# Southeast Sweaters Ltd. (New)

19<sup>th</sup> February 2018

# Observation

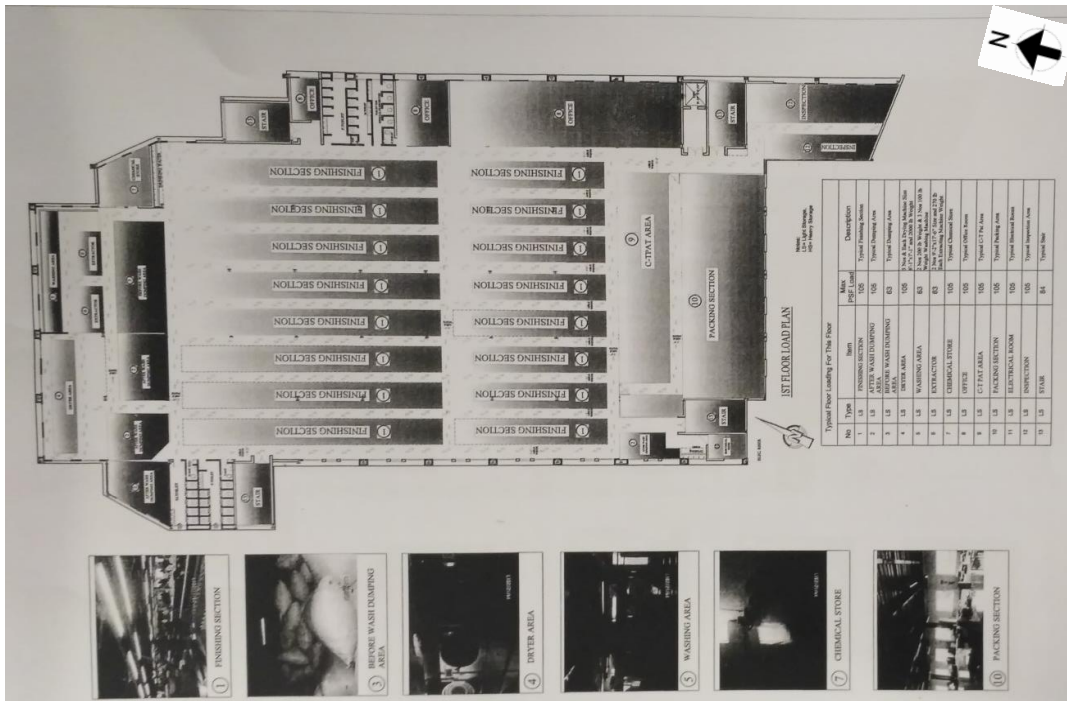
Load was measured below 2Kpa on every floor and FOS calculation for internal column was found satisfactory considering 3kPa allowable floor live loading.

Factory engineer prepared a load plan for 1<sup>st</sup> to 3<sup>rd</sup> floor considering 5 kPa as allowable load and 3Kpa for 4<sup>th</sup> floor dining area. Factory is required to verify the load plan by ACCORD if factory management intends to maintain the load plan.

Factory is required to maintain the floor live load 3 kPa until further verification by ACCORD.

Rafter layout of roof top shed

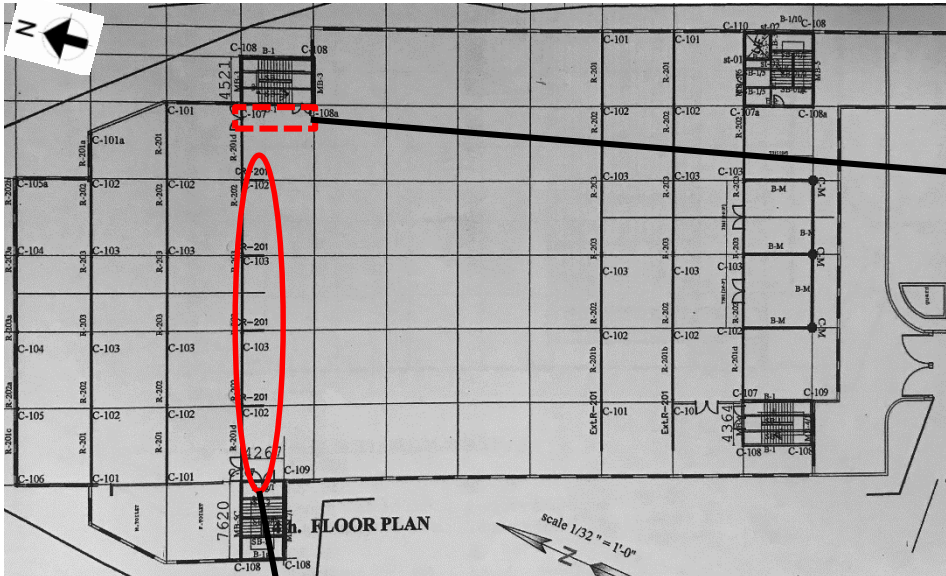
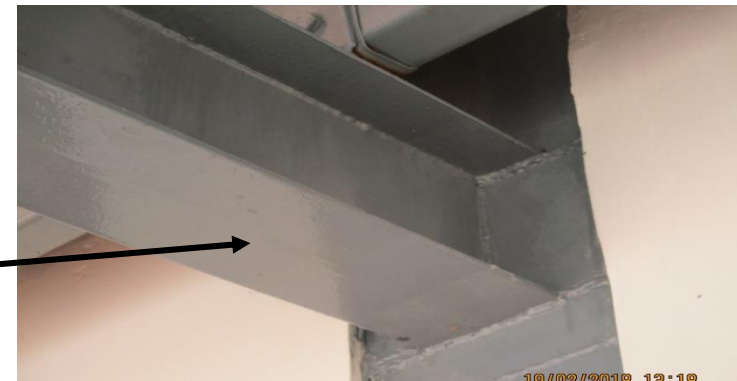
Extended canopy in front of the stair case did not shown in drawing

Extended beam of roof top shed was shown as CR-201 section but detail of the beam was not available

The extended beam is welded with the steel column

Sub beam layout

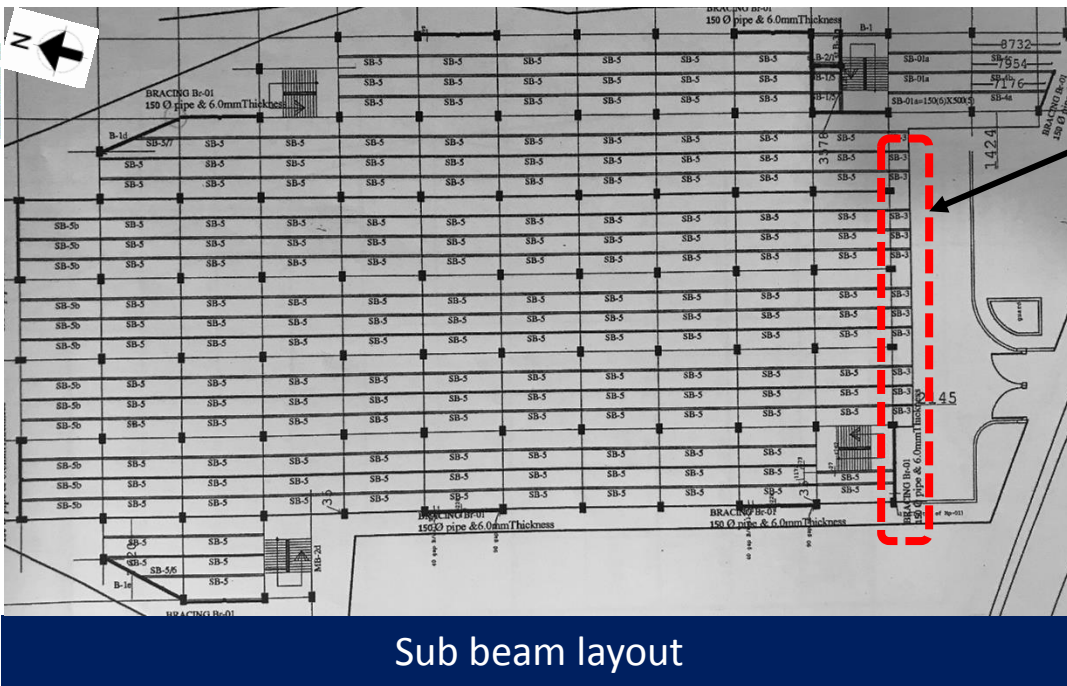
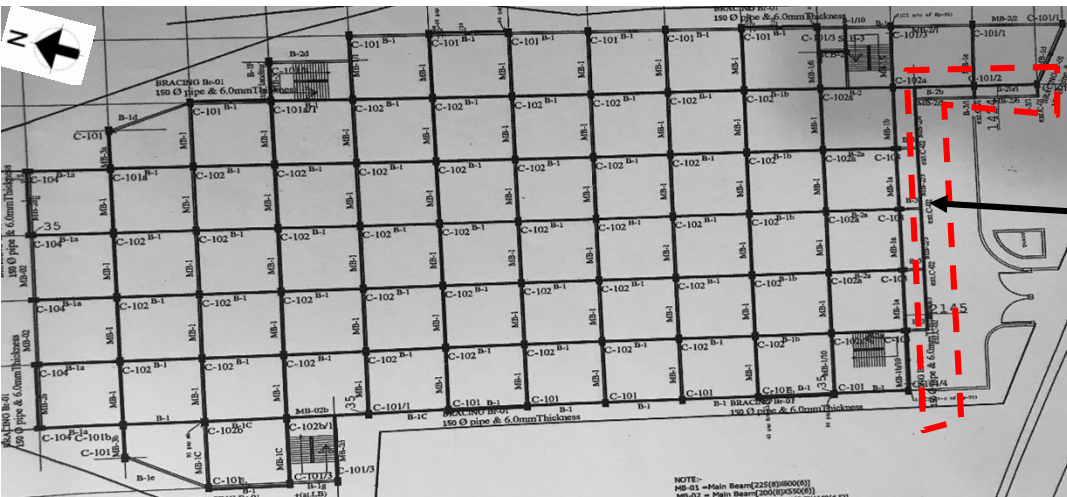
Detail of SB-3 type sub-beam was absent in drawing

Column layout for 1<sup>st</sup> to 3<sup>rd</sup> floor

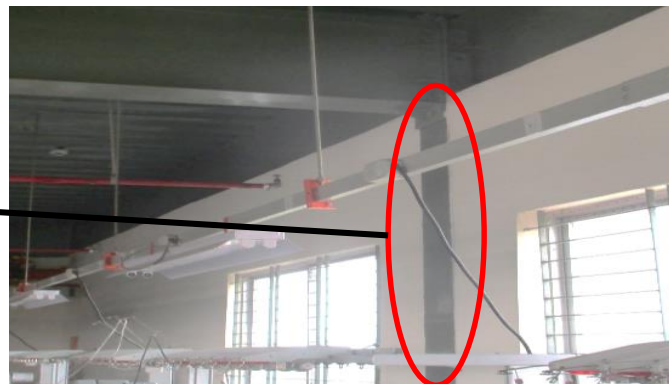
On south side, some non load bearing steel strut was observed and no detail was found in drawing

4<sup>th</sup> floor layout

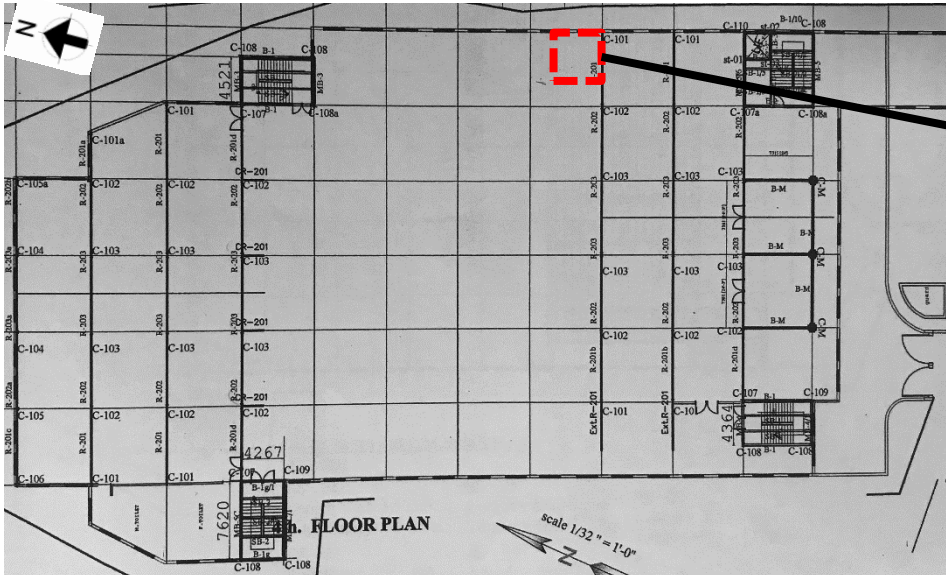
The undocumented lightweight shed

The support condition of roof top shed was vulnerable and non engineered due to poor detailing. The stability system is required to be verified under lateral loads.

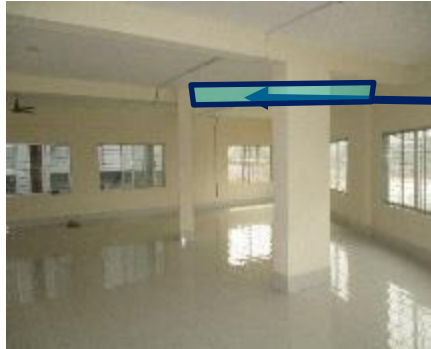
The highlighted columns are susceptible to vehicle impact. Factory is required to take necessary steps to protect the columns from vehicle impact.

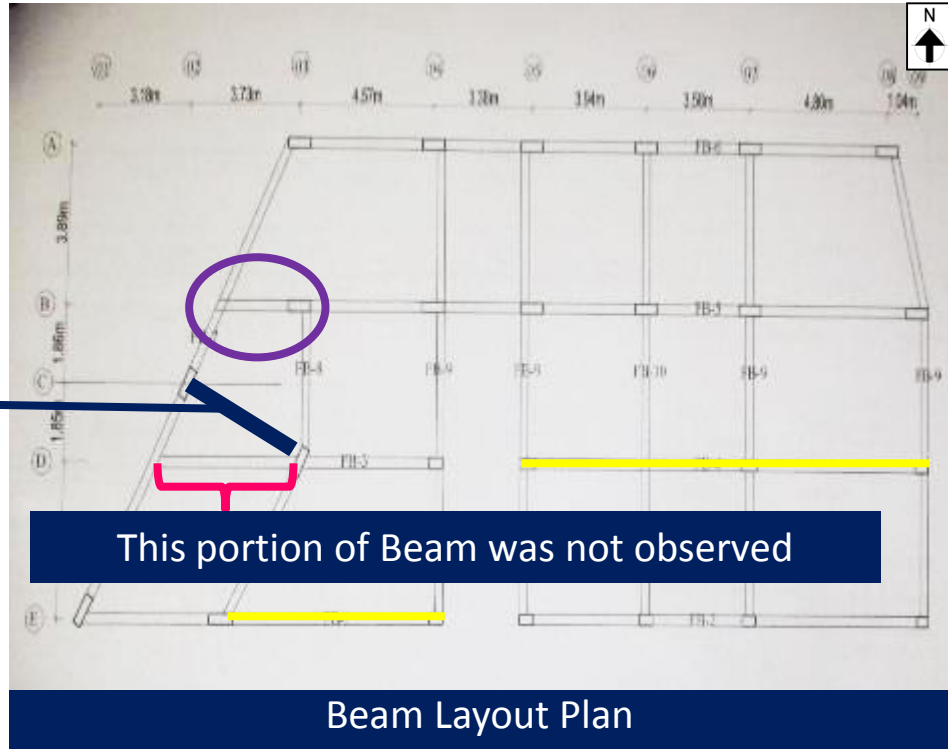
Beam found on the marked location

This portion of Beam was not observed

Down stand observed 250 mm instead of 325 mm

During inspection, Down stand of the all the beams (except the mentioned) was observed 250 mm instead of 325 mm. Factory is required to revise As – Built drawing as per actual condition.

Down Stand of the highlighted (yellow marked) beam was observed 450 mm instead of 325 mm on GF and 1st Floor

Section of Utility Building

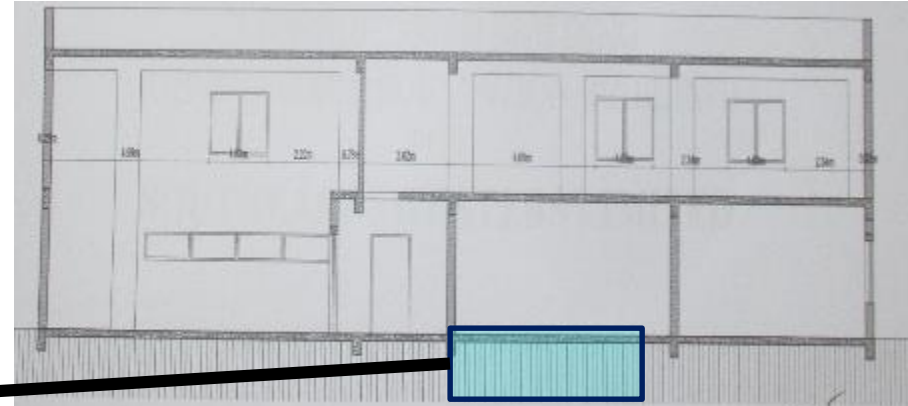
Pump Room below Ground Floor

During inspection, a pump room was observed on the marked position below ground floor level of the utility Building which was not included in As-Built drawing. Factory is required to update the As-Built drawing as per actual condition.

Steel Stair outside of the utility building

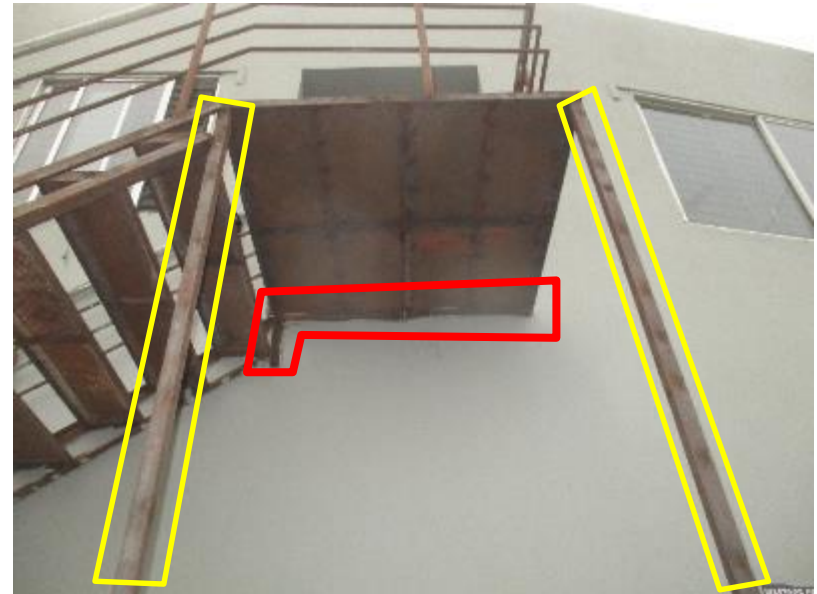
Non- engineered connections and slender columns

Corrosion observed on the stair

The support condition of the steel stair at the east side of the utility Building was appeared to be non-engineered due to poor implementation of connection and slender steel column support. Factory is required to replace the steel stair with a engineered steel stair.

Structural System of Generator room

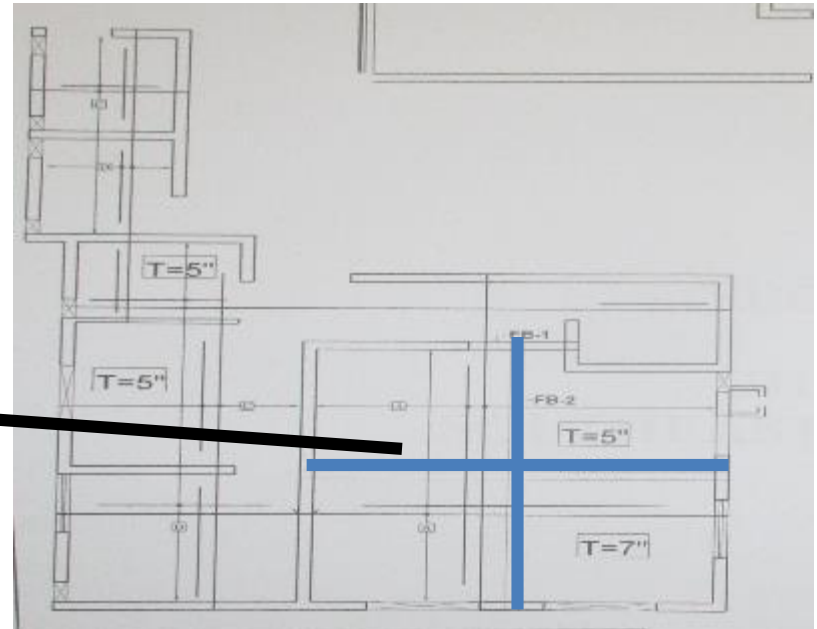
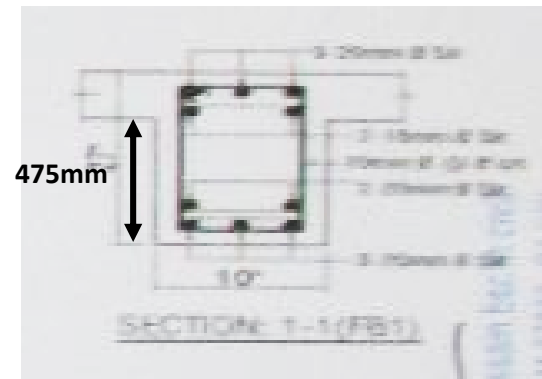
Down stand of the roof beam on generator room was observed 300 mm instead of 475 mm. Factory is required to revise the As-Built drawing as per actual condition.
